OXY USA Inc. - Proposed  
LaMunyon Federal #5  
API No. 30-025-10813

OXY USA Inc.  
NMLC-030187: Lamunyon Federal #5  
API: 30-025-10813  
Lea County, New Mexico

RE: Plugging and Abandonment Requirements, Conditions of Approval

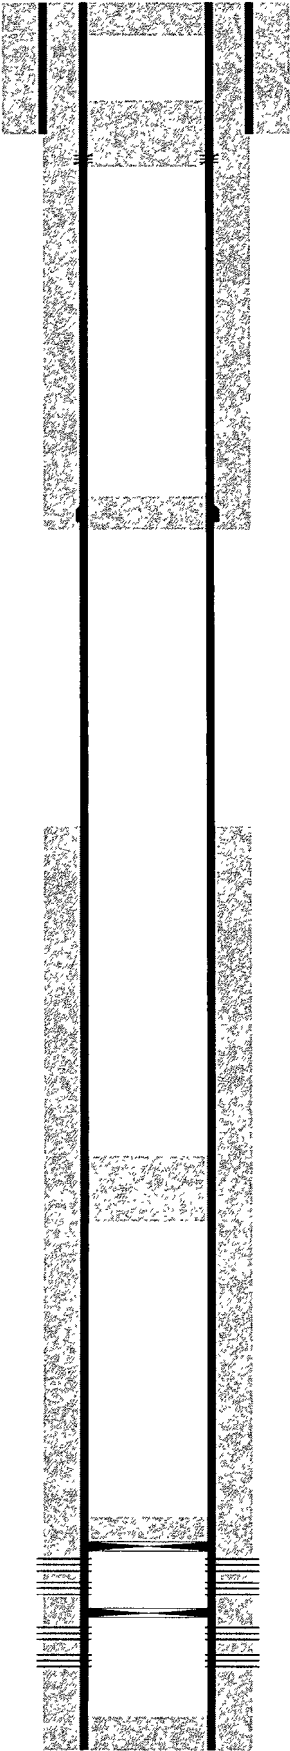
1. OK (Perfs)
2. WOC and tag at 2575 or shallower – Otherwise OK (Yates – BOS)
3. CHANGE: Perf and squeeze plug from 1210'-1098'. If injection rate cannot be established, spot plug 50' below perfs. WOC and tag at 1098' or shallower. (DV Tool – TOS)
4. OK (Casing shoe)
5. OK (Surface)
6. Submit a subsequent report to the BLM.
